**RE: 6<sup>th</sup> and Haines Redevelopment  
Conceptual Grading and Drainage Plan  
Stamp Date: 9/22/17  
Hydrology File: H14D108**

Based upon the information provided in your resubmittal received 9/25/17, the Conceptual Grading and Drainage Plan is approved for action by the DRB on the Site Plan for Building Permit and Site Plan for Subdivision.

**SDP-3.1**  
SHEET 3 OF 10

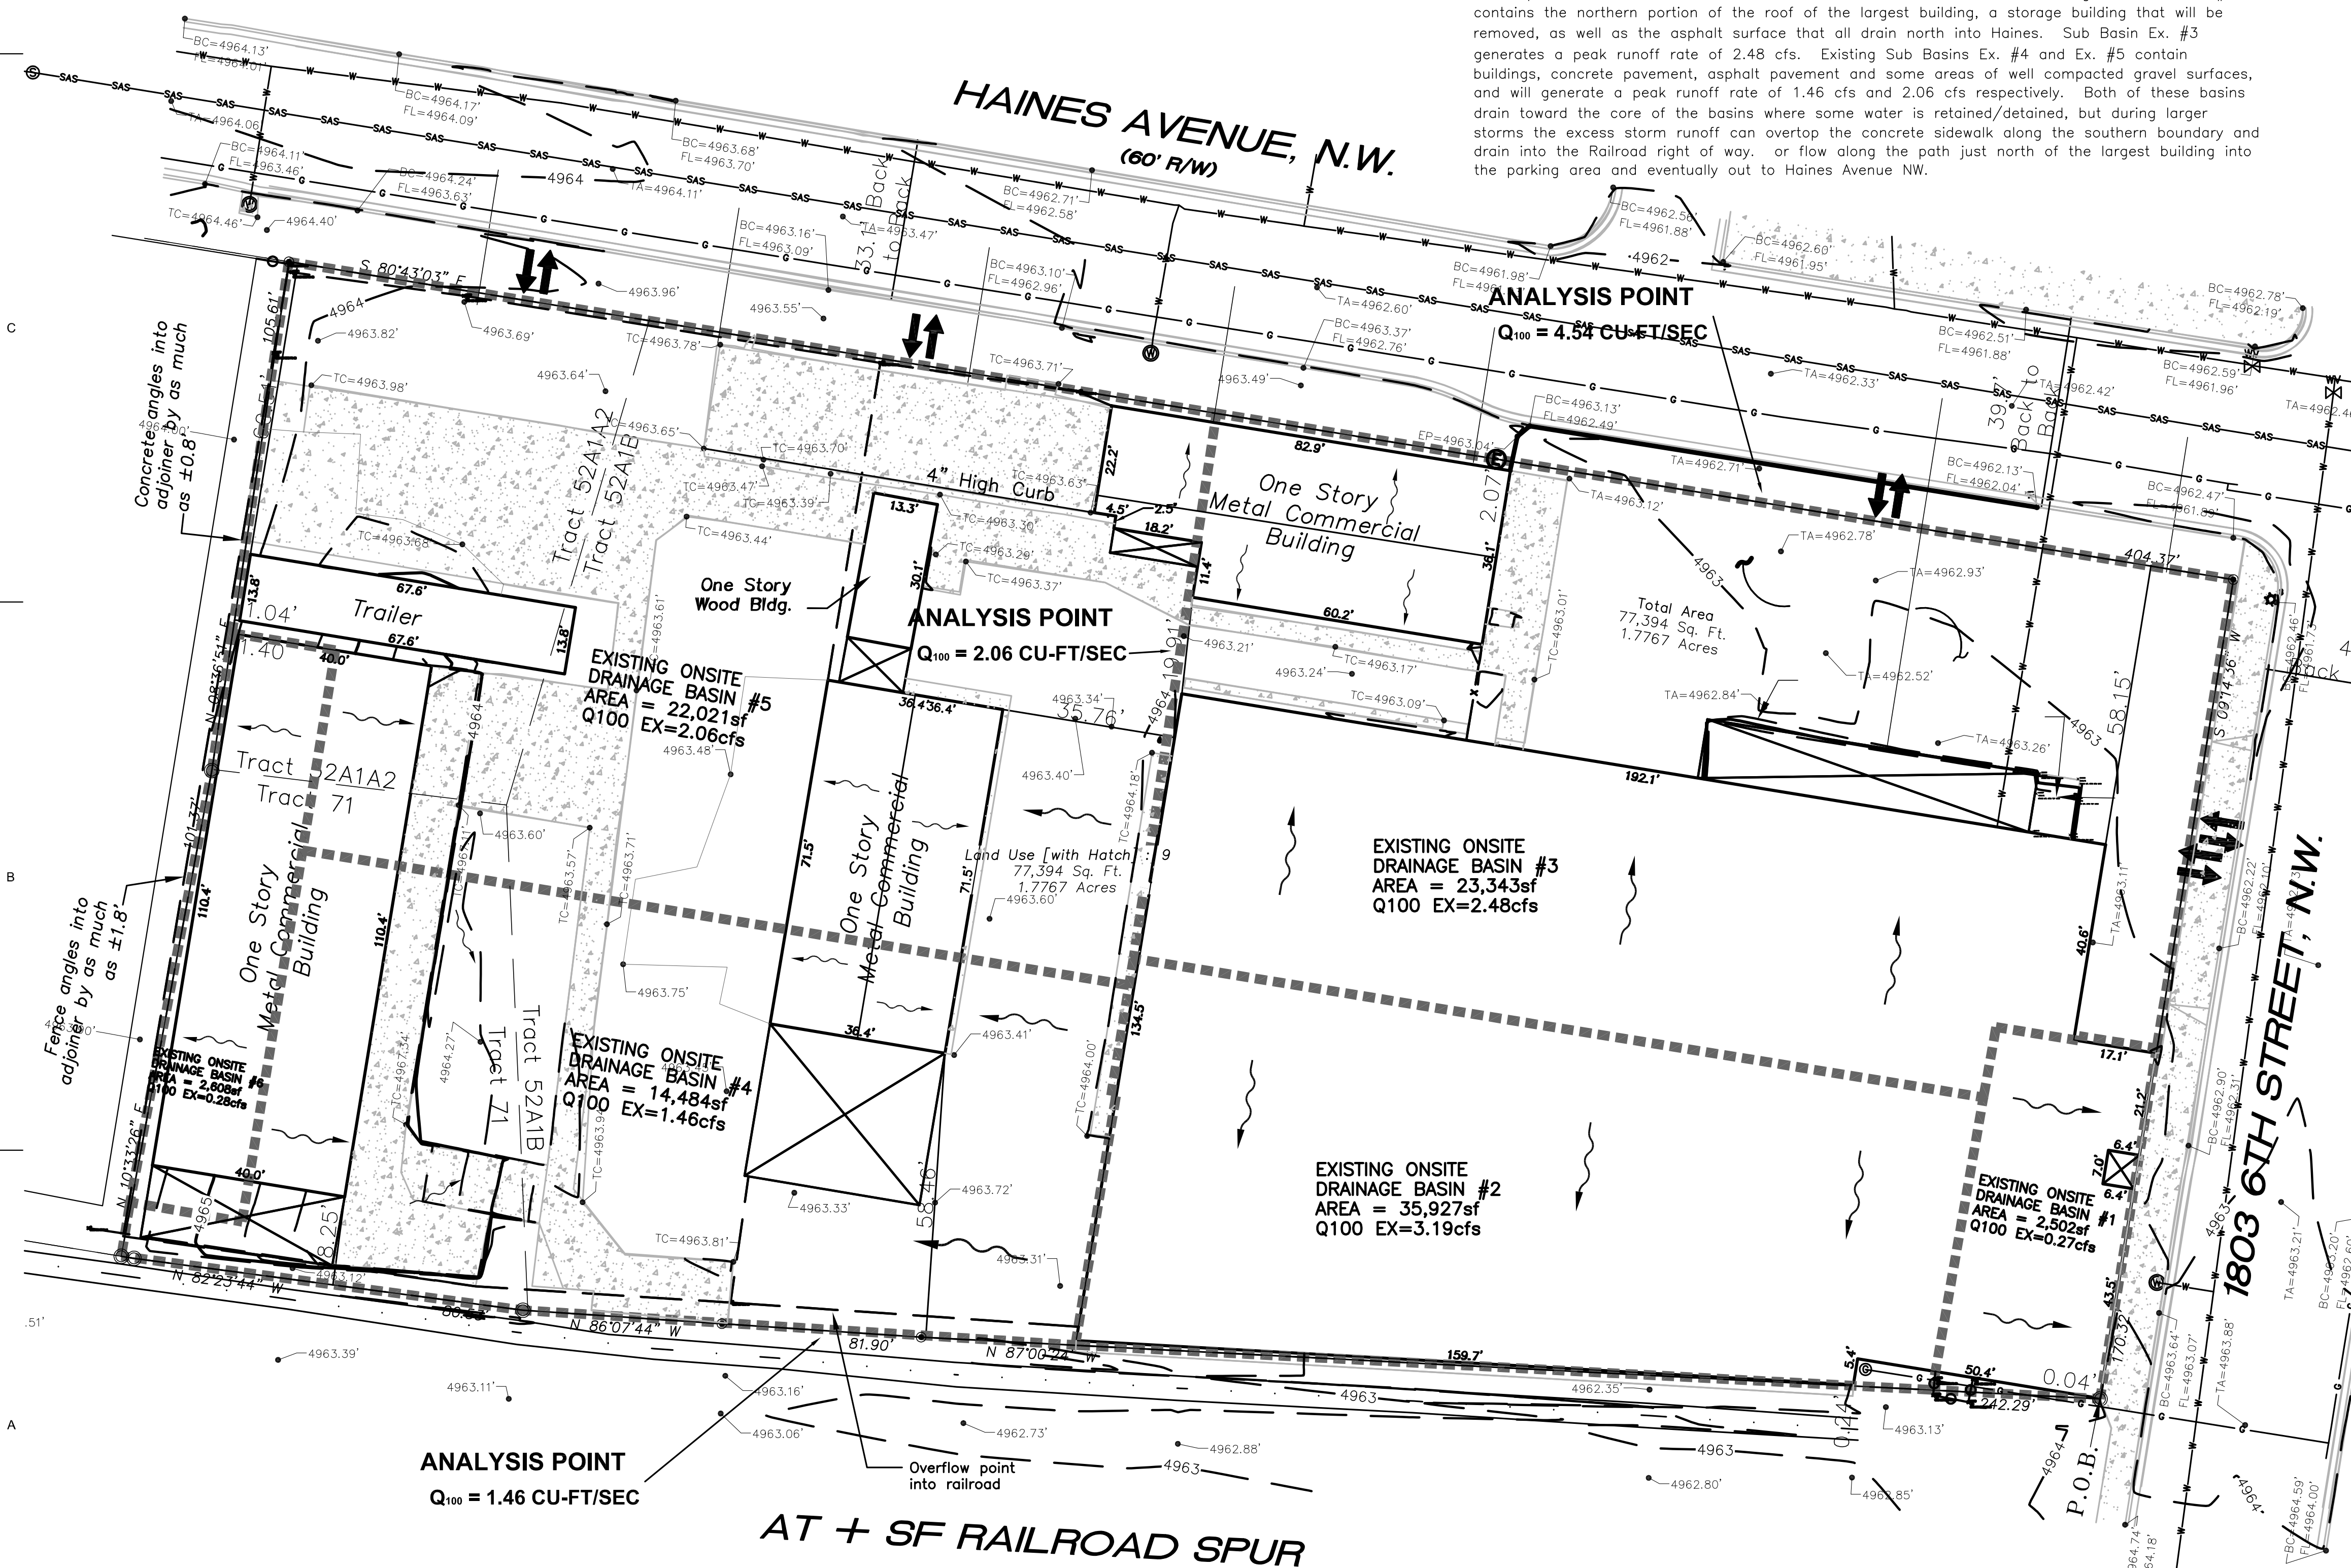
- On Sheets SDP-3.1 & SDP-3.2, please call the sheets "Conceptual Grading and Drainage Plan" and add a note stating "Not for Construction".
- On Sheets SDP-3.2, please call change the Basins to "Proposed" from "Existing".
- On Sheets SDP-3.2, please add the finished floor elevation to the main building.

SHEET NUMBER  
**SDP-3.2**  
SHEET 4 OF 10

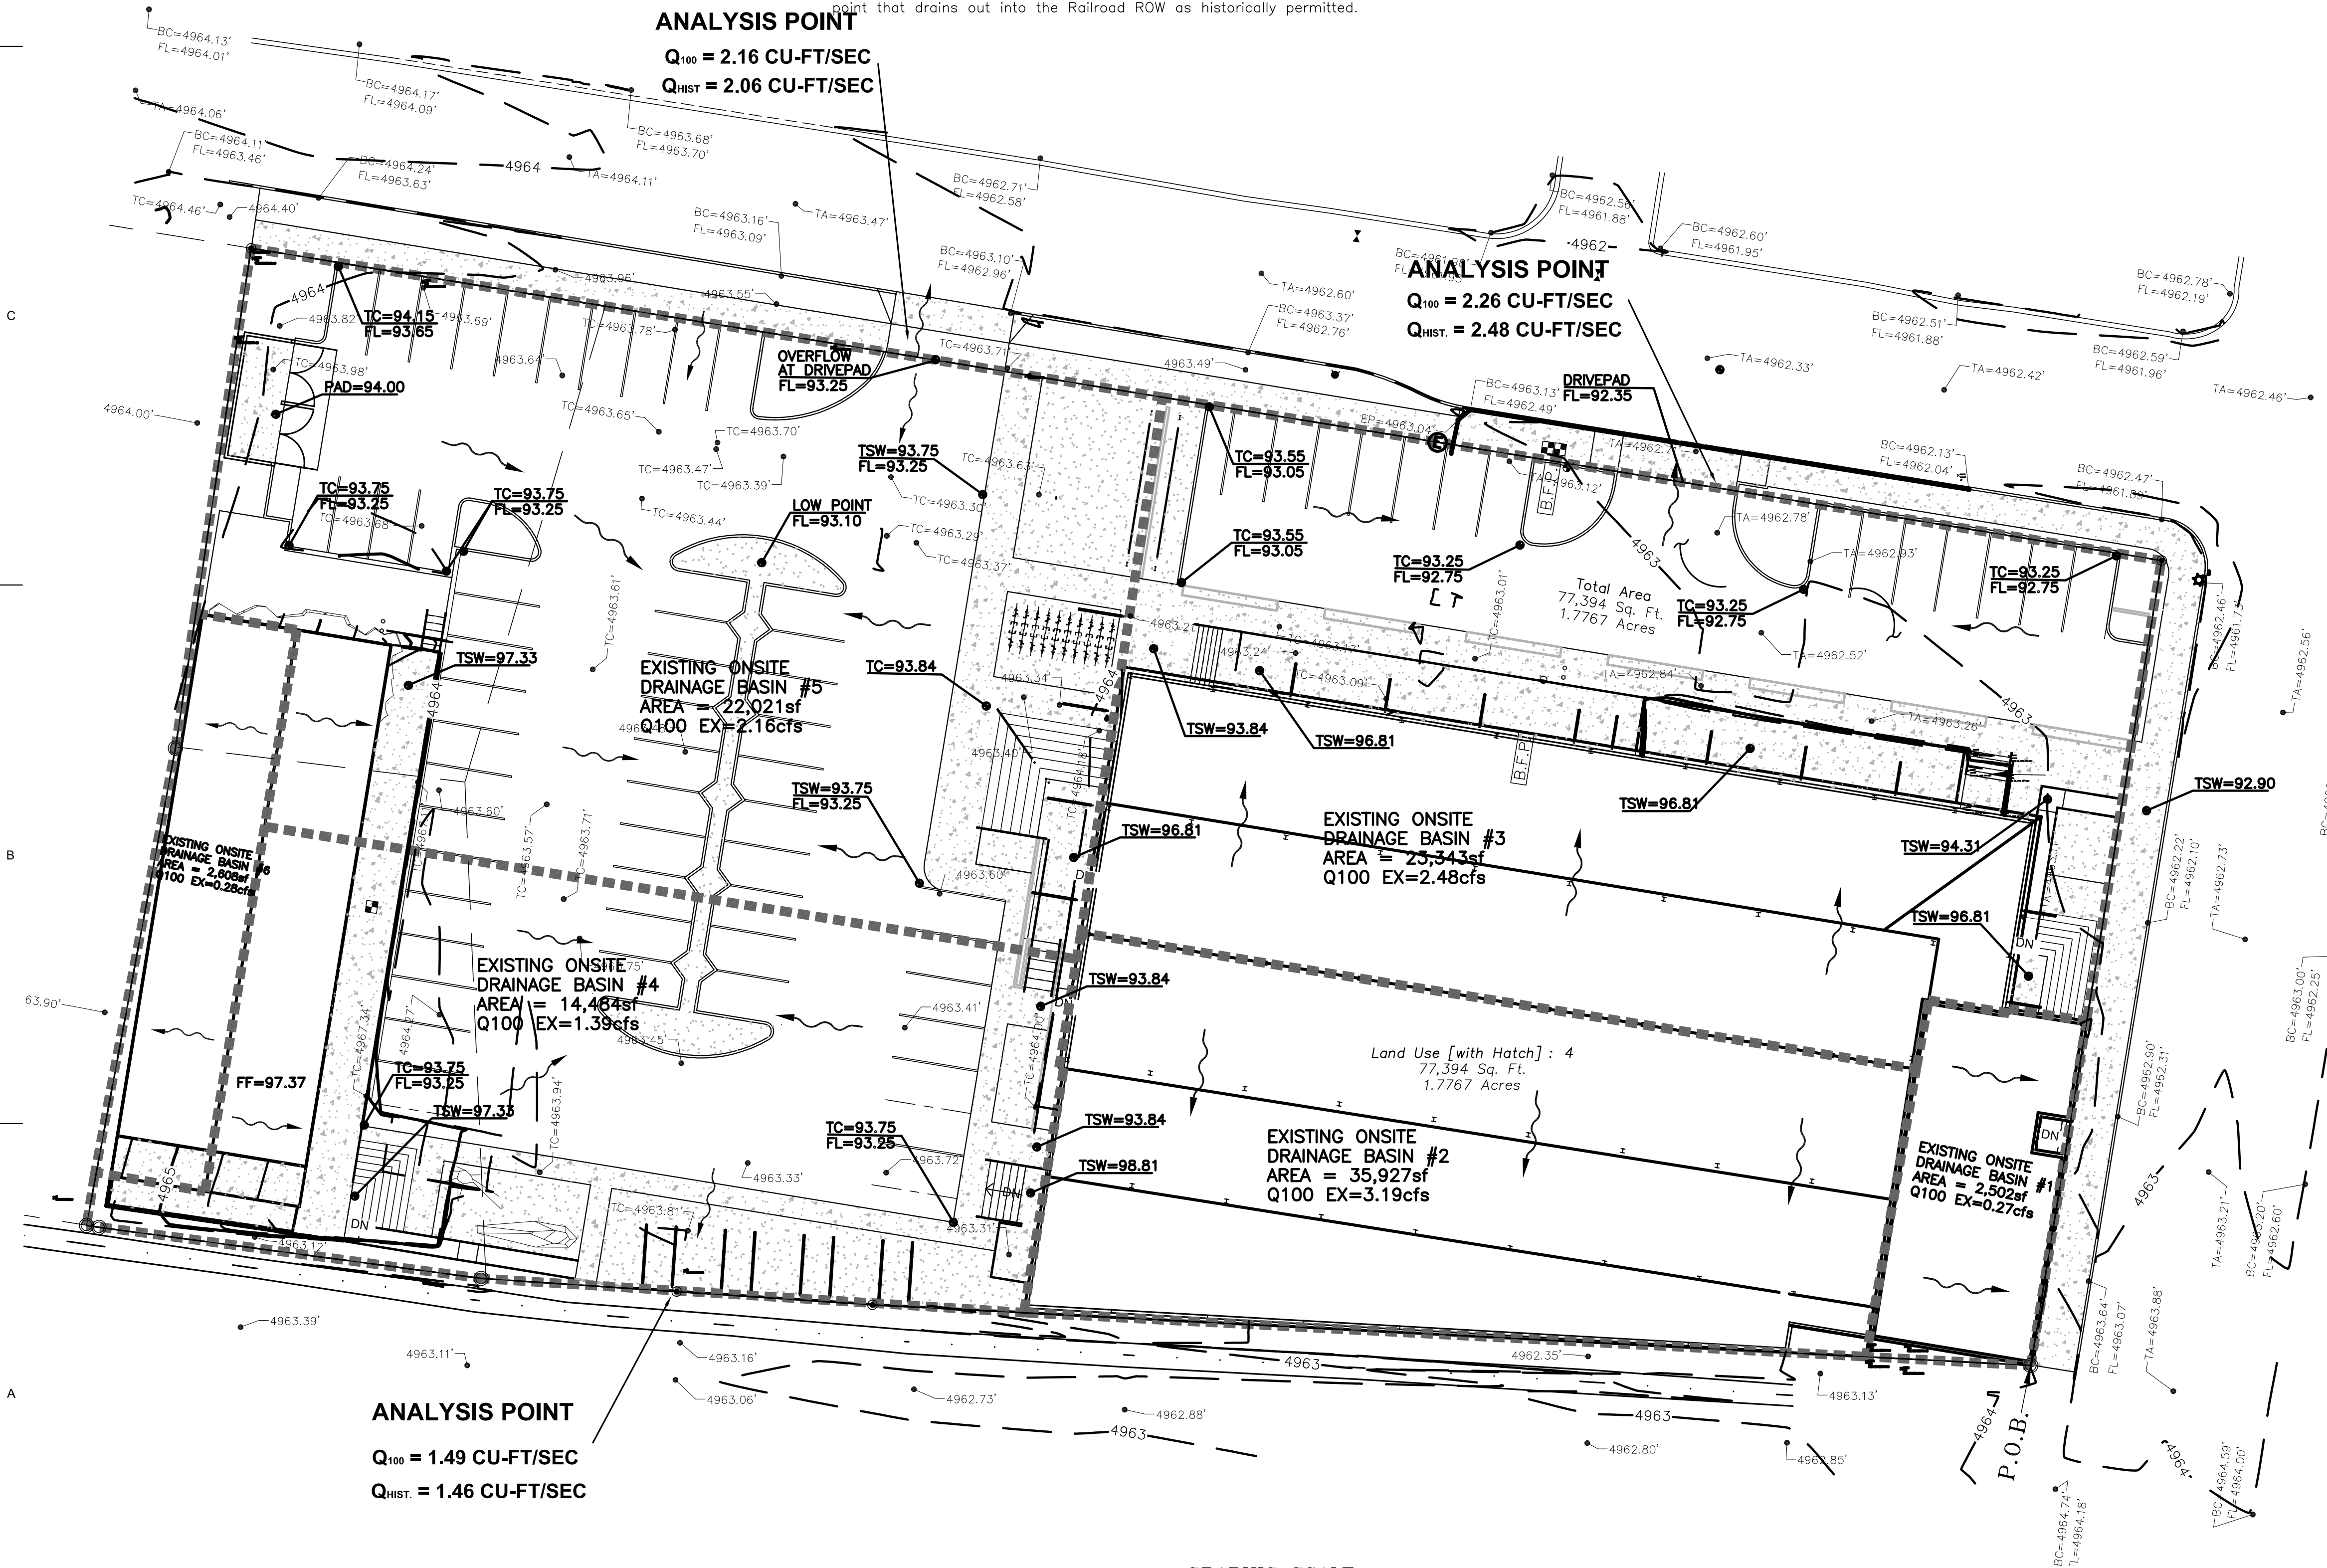
- Please review the Proposed 100 year discharge. I checked Pro 4 and came up with 1.38 cfs instead of your 1.49 cfs.
- Not all basins need a first flush pond. Only Basin Pro 5 needs one since the impervious area increased.
- Please add a curb cut or cuts to allow runoff to inter the first flush pond within the depressed landscape areas.
- Please show the weir calculations for the proposed curb cut or cuts.
